MEMORANDUM

SUBJECT: Site Plan Control Application
14 George Street, Markham Village Heritage Conservation District
Proposed Addition to an Existing Heritage Dwelling and Detached
Garage/Accessory Building
SPC 21 104346 & A/021/21

Existing Front (East) Elevation

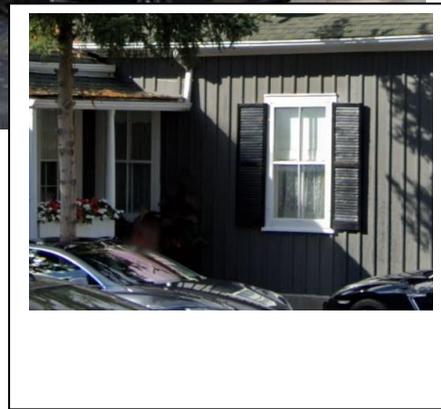
Staff Comment: the two new 4 pane windows above the main windows appear larger than the existing opening. Two new verandas are proposed – need further detail on column design and should be more reflective of a traditional veranda. Also notes are required on elevation drawings indicating original windows to remain and original siding/returned eaves to remain
